## "OOPS, WE GOOFED"

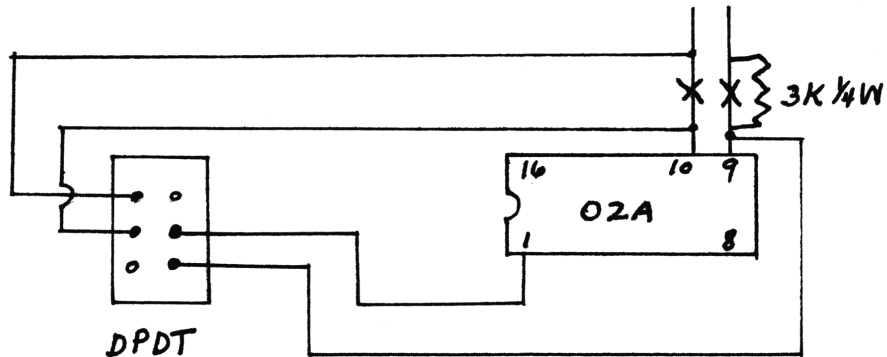
- Vol. 1, p. 61: COURIER CENTURION, Step 3: Change wire color green to yellow.
- Vol. 13, p. 27: RAY JEFFERSON - Correction for Step 3 & 4 and drawing:  
3. Bridge cut of no. 9 with 3K resistor.  
4. Wire up a DPDT Center-Off Switch as shown:
